CITY OF UNLEY
COUNCIL ASSESSMENT PANEL

20 June 2023

ITEM 1**DEVELOPMENT APPLICATION - 22039582 – 91 KENILWORTH ROAD, PARKSIDE SA 5063**

DEVELOPMENT APPLICATION - 22039582 – 91 KENILWORTH ROAD, PARKSIDE SA 5063

Figure 2: View of the outbuilding from the rear yard of the subject land.

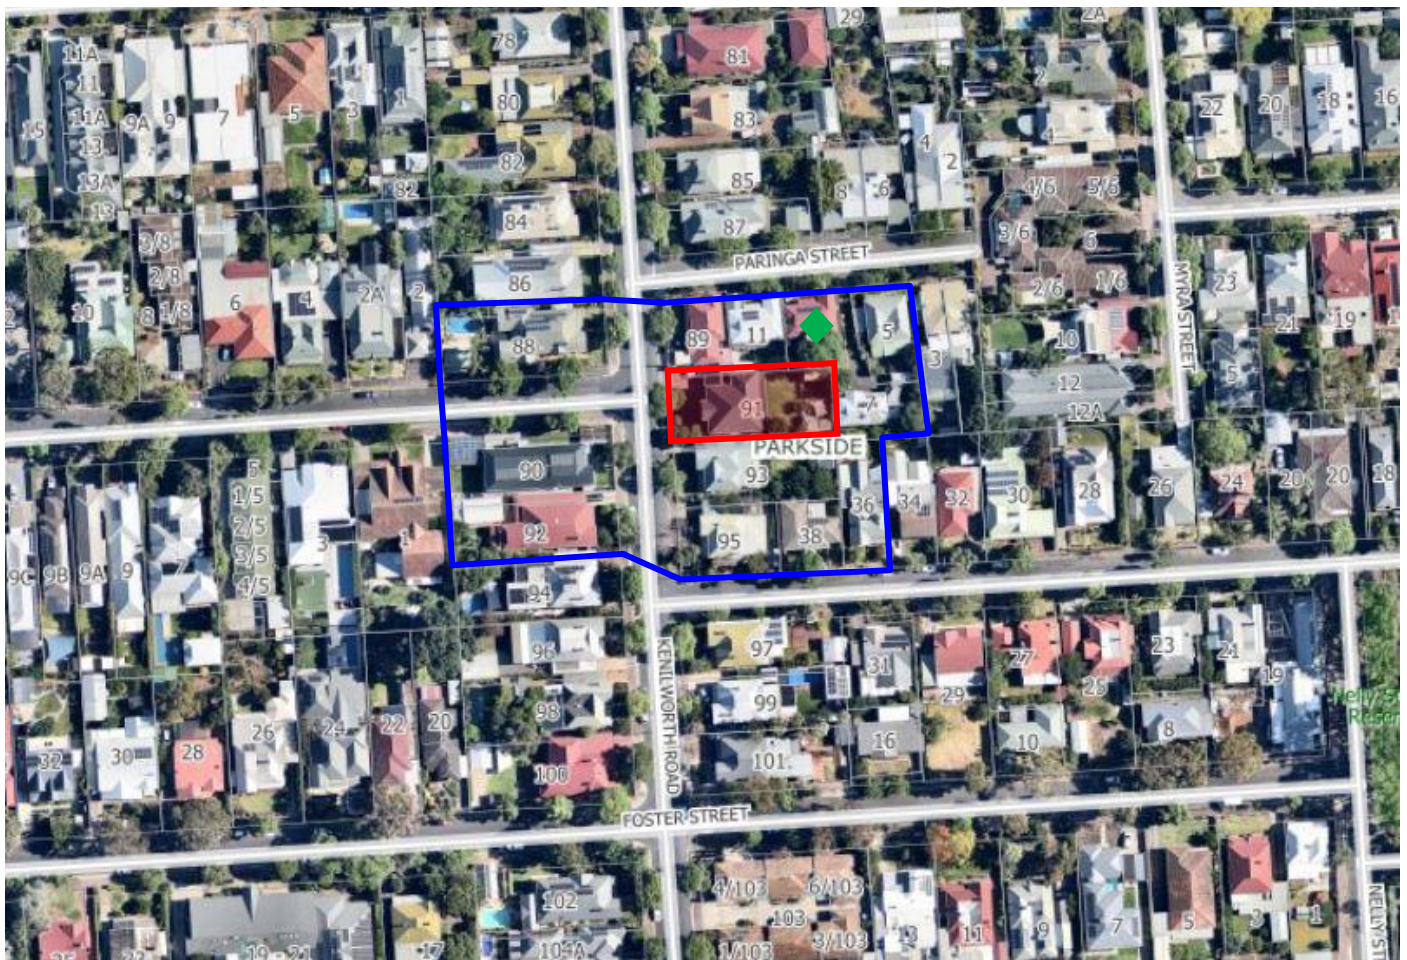
The flue will extent 600mm above the ridge of the outbuilding, with an overall height of 3.6m when measured from the FFL of the outbuilding. The proposed structure will not be viewed from the public realm and will only be readily noticeable to the immediate adjacent properties, satisfying **PO 1.1** and **2.1 of Historic Area Overlay**. As detailed earlier, in response to the representations received against the proposal, the applicant proposed to re-locate the oven and flue to the southern side of the outbuilding to reduce both the visual impact and the nuisance of the smoke emissions when the oven is in use. The flue is proposed to be located away from adjoining properties Private Open Space and is considered to mitigate any adverse effects to adjoining properties satisfying **DO 1 – General Development Policies – Interface between Land Uses**.

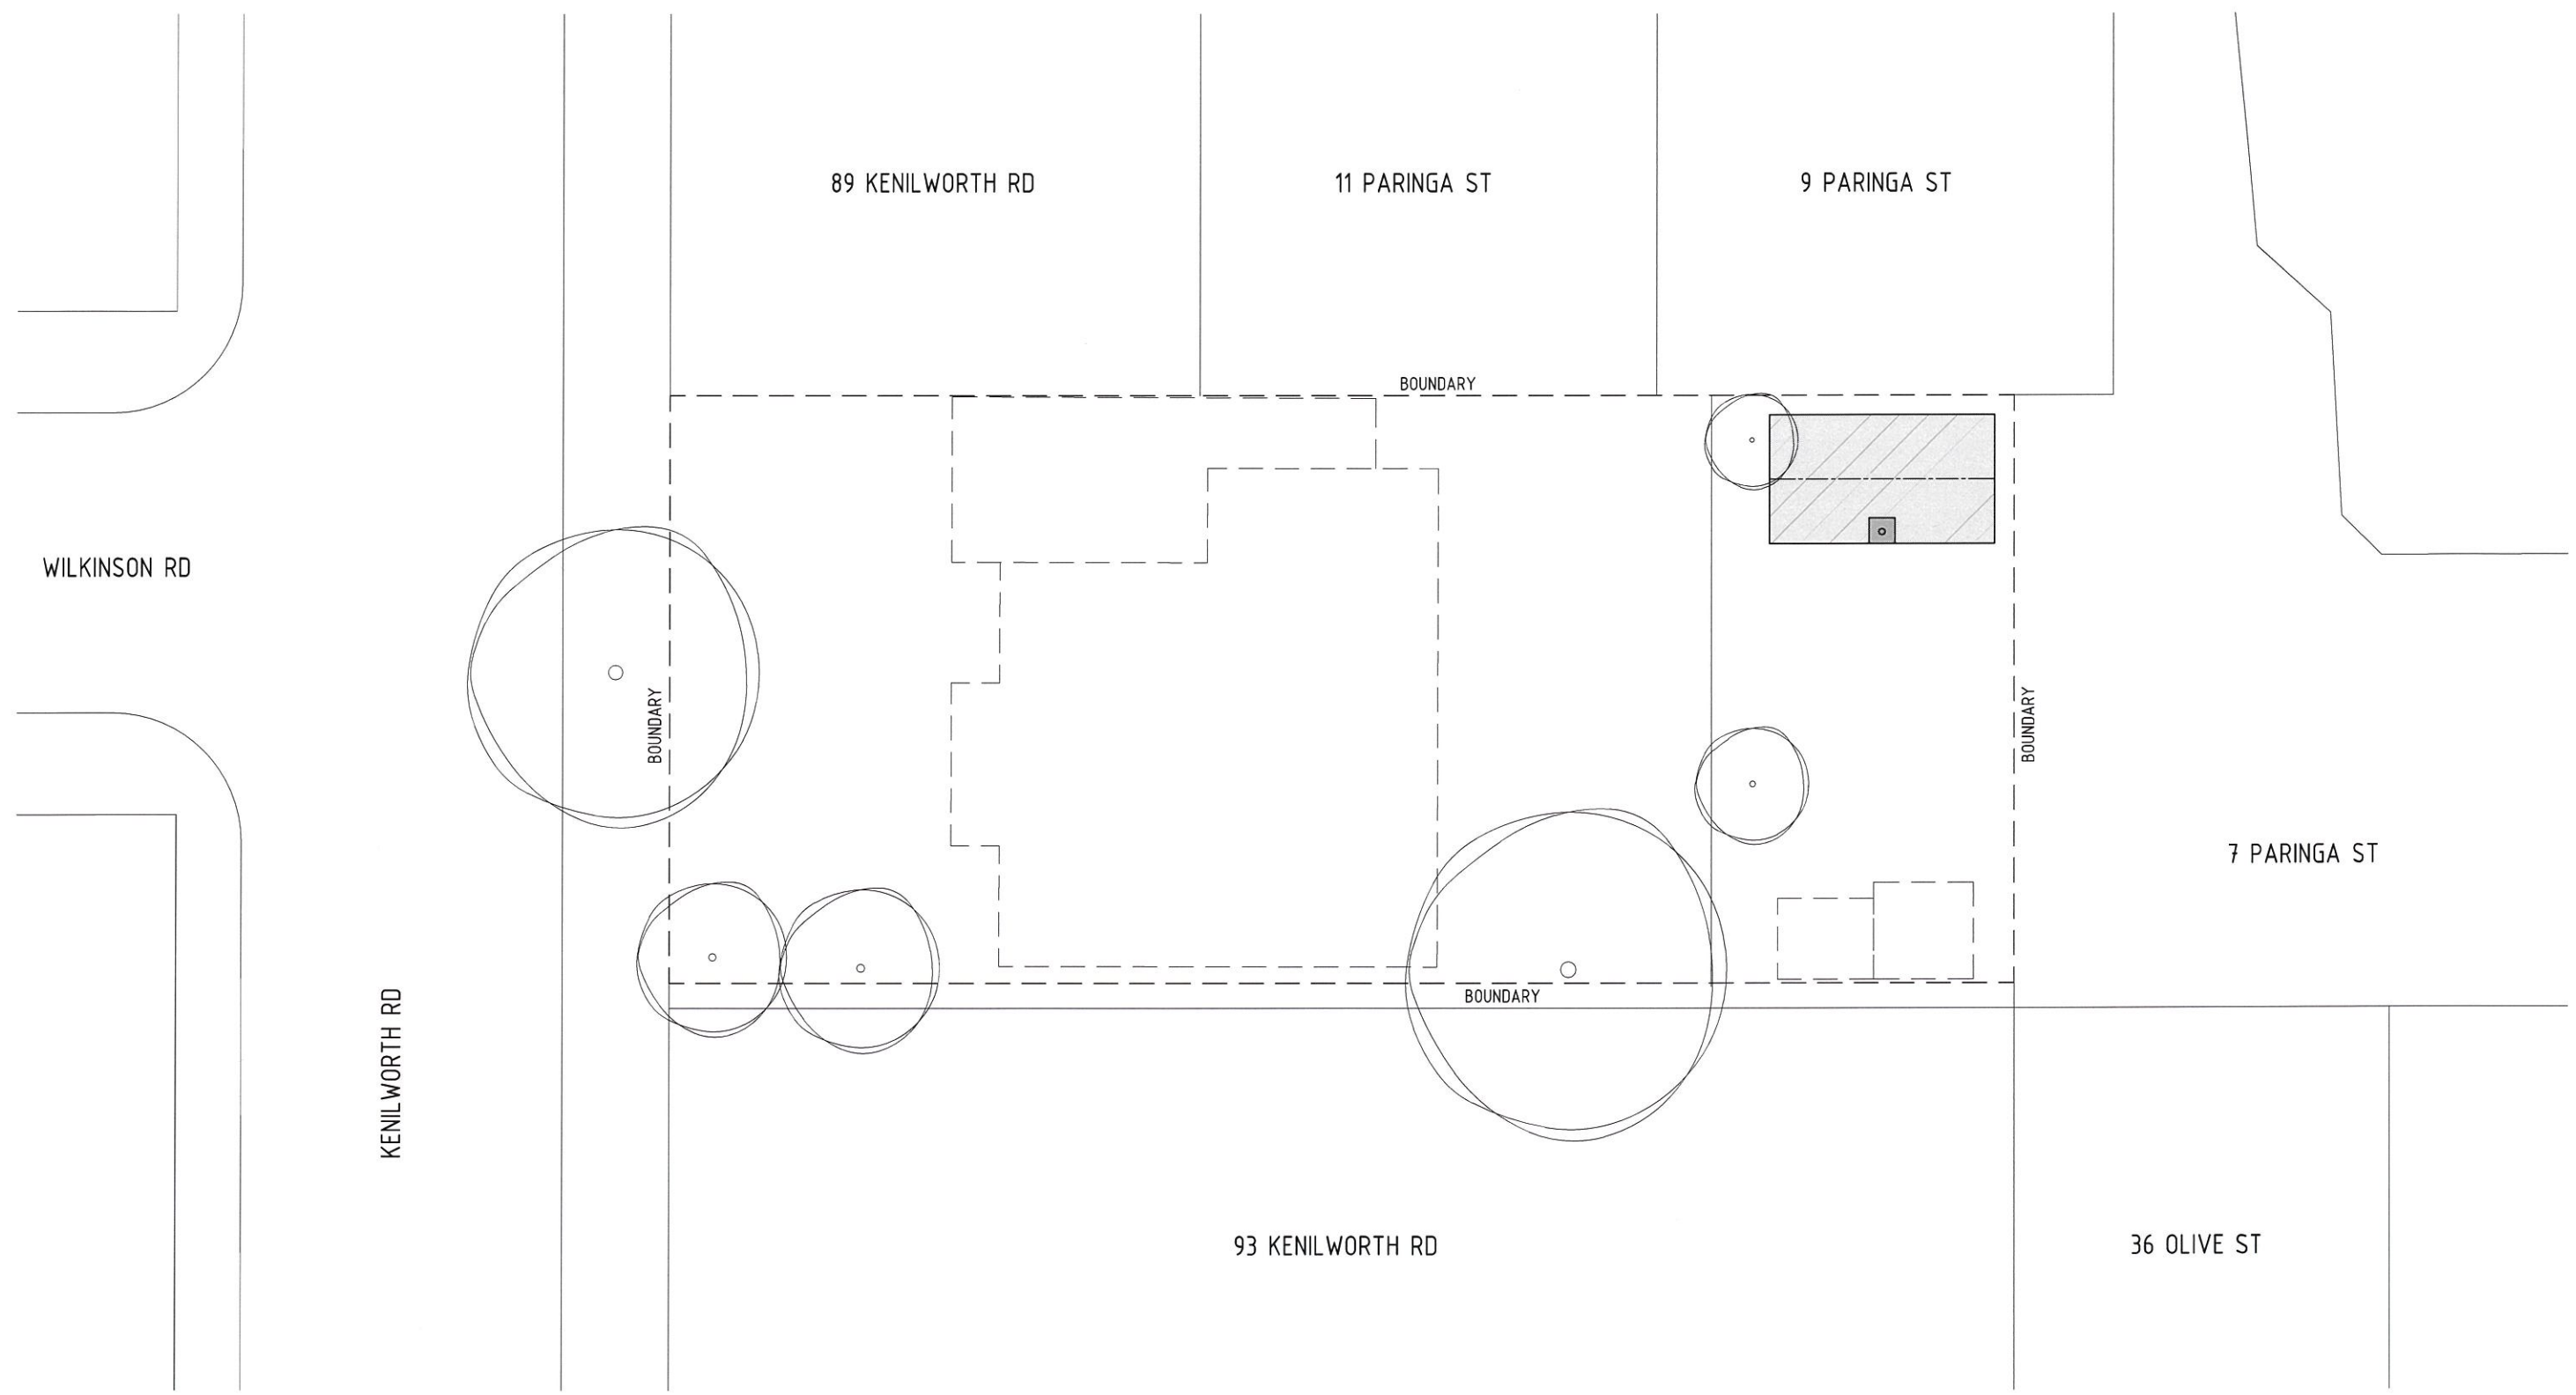
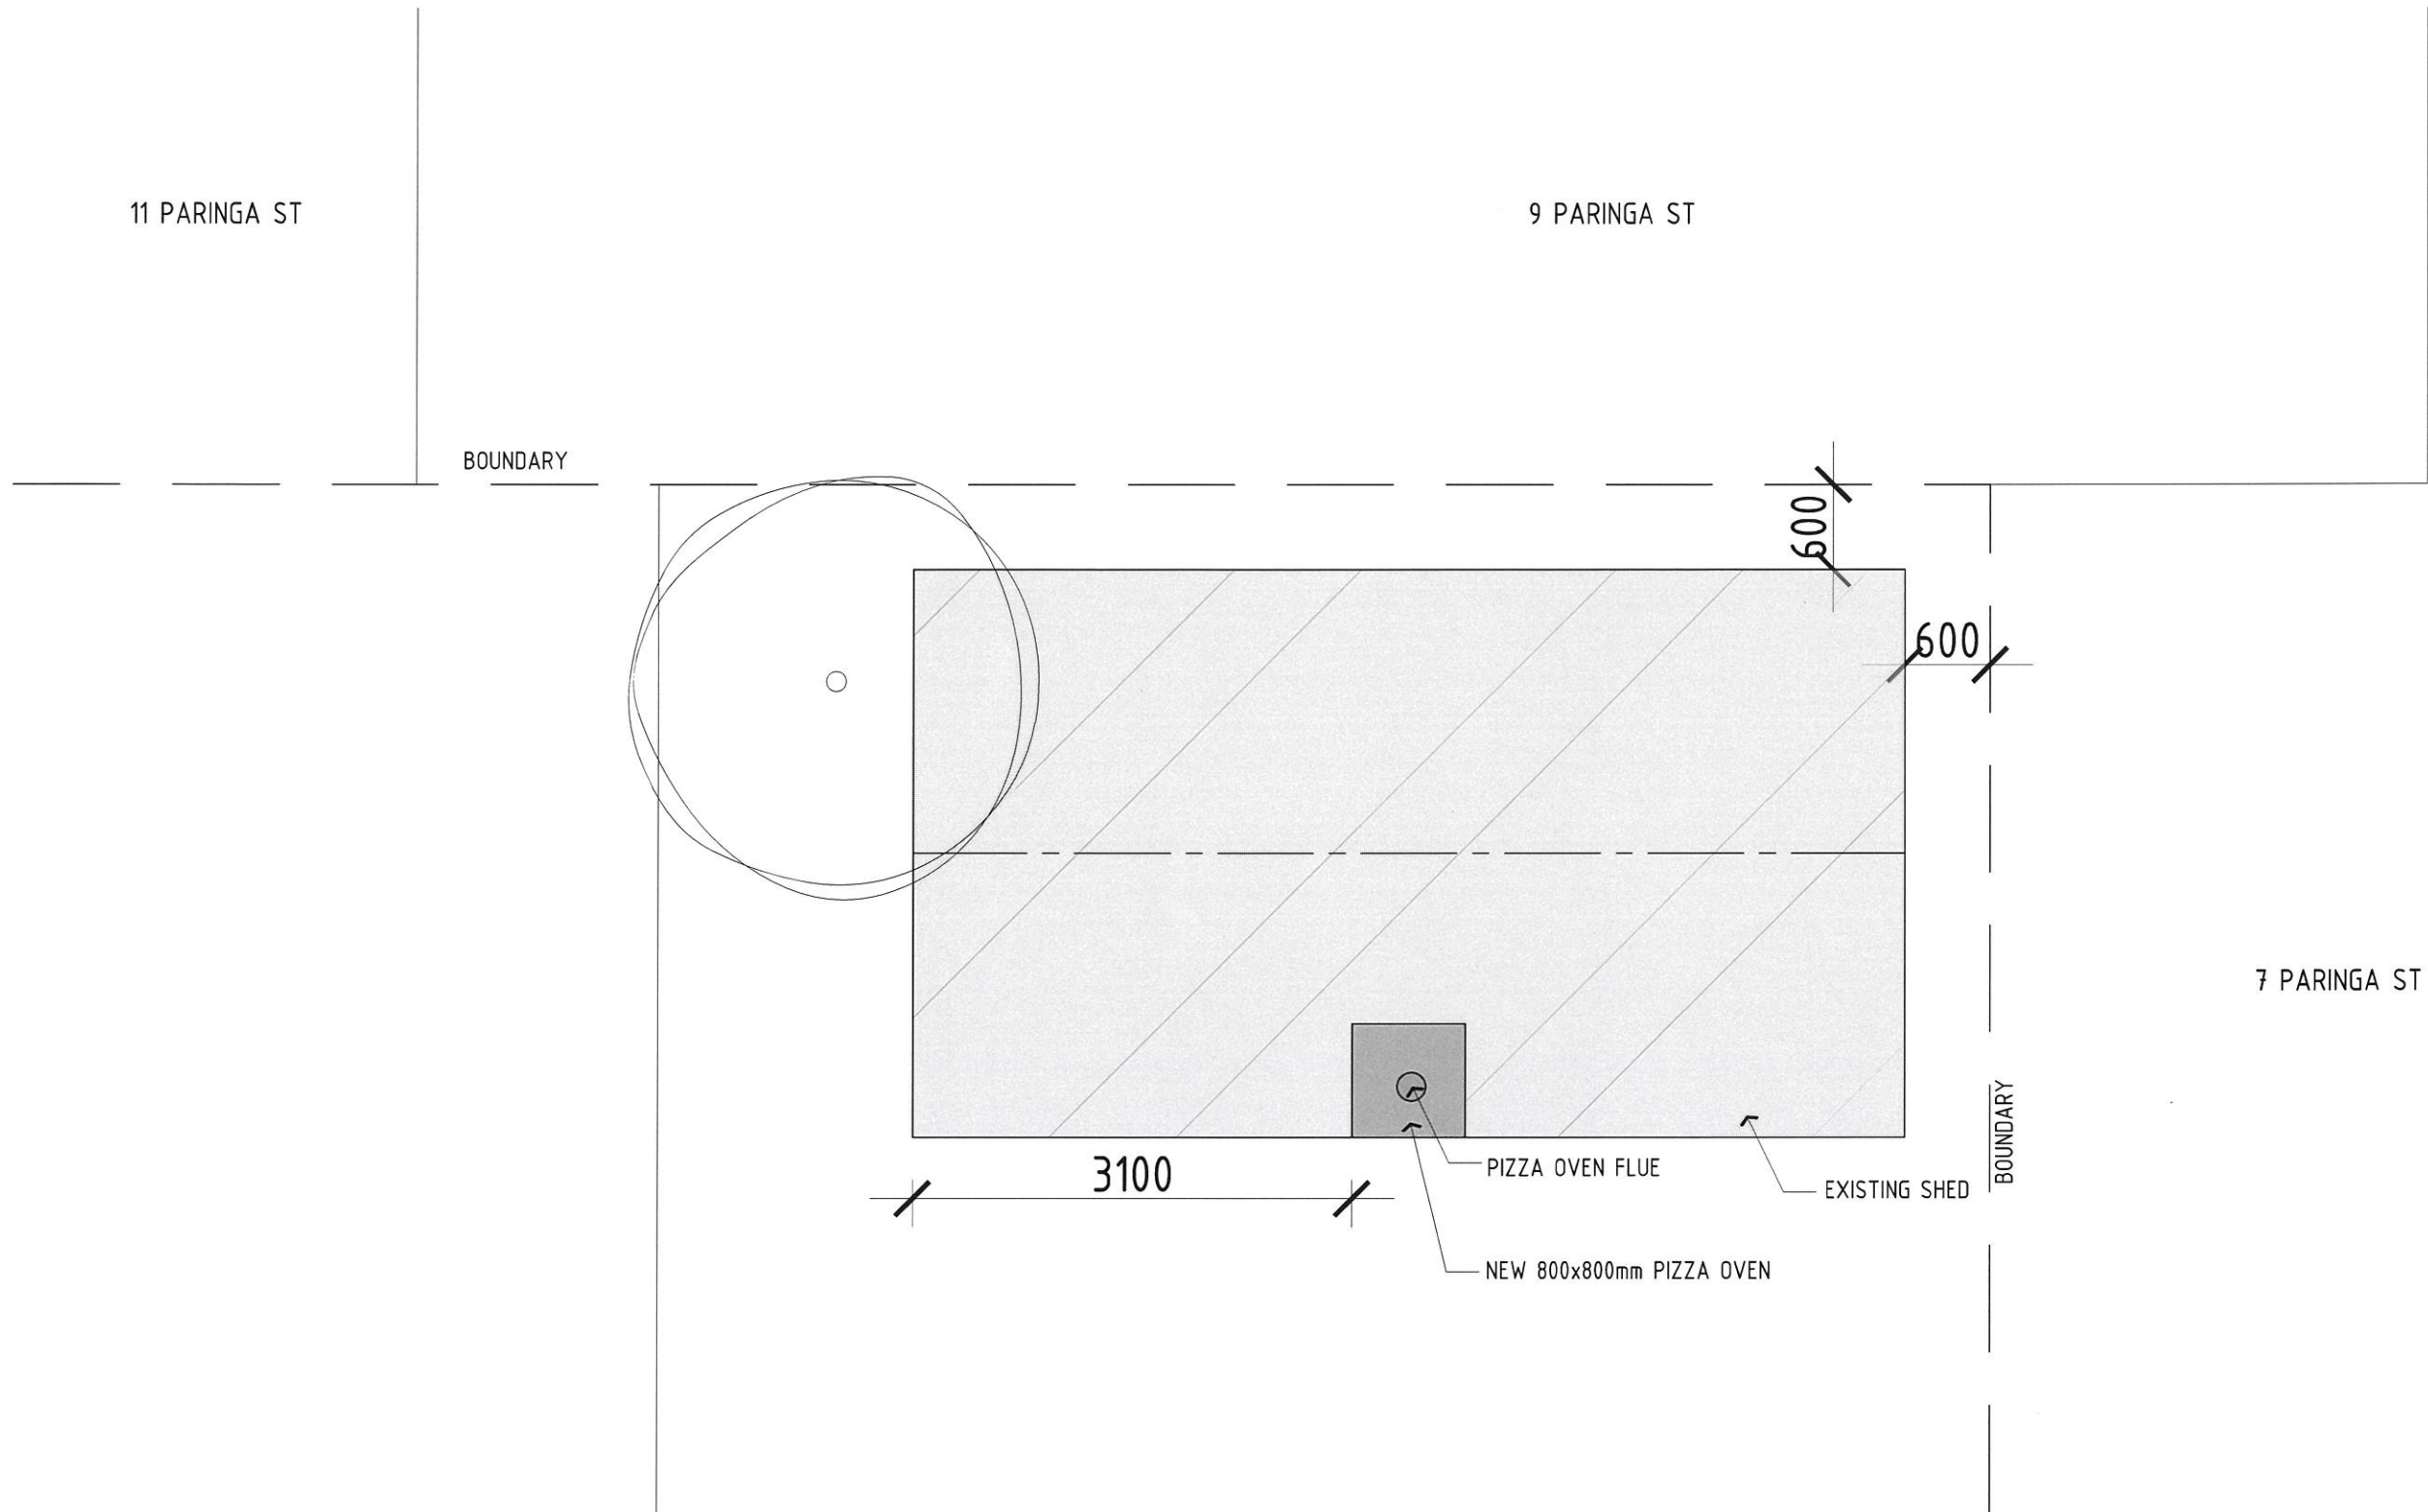
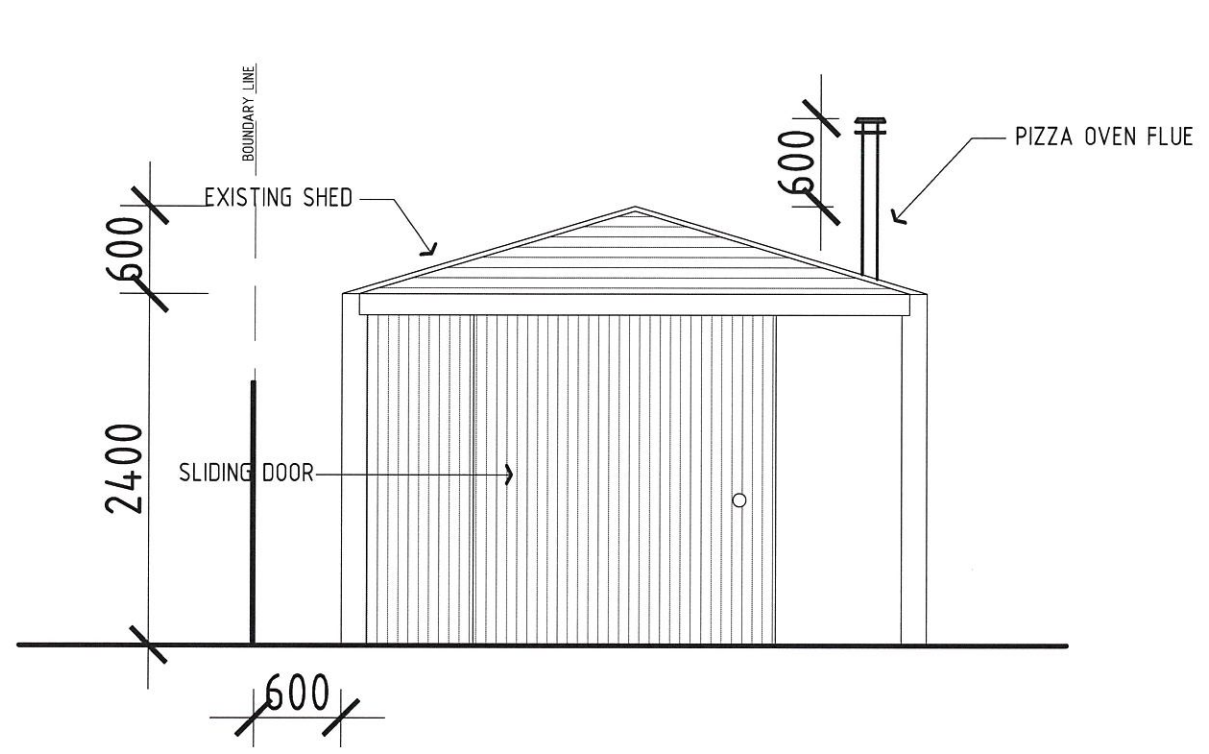
The proposal seeks to install a flue from a pizza oven on the southern side of the existing outbuilding. The flue will extend through the roof of the outbuilding and sited 600mm above the pitch of the roof. A copy of the plans is contained in **Attachment 1**.

1. Flue has now been moved to satisfy requirements of the planning and Design code(see attached diagram).
2. Pizza oven is operated only on very few occasions during the year, which is not more than once a month at most (and most definitely not every weekend).
3. Neighbours alongside and behind the property of 91 kenilworth road, operated a bbq which they cook meat on most weeks and no complaint has ever been lodged, in regards to smoke and odour.
4. Please note most if not all 'reasons' have now been adhered to.
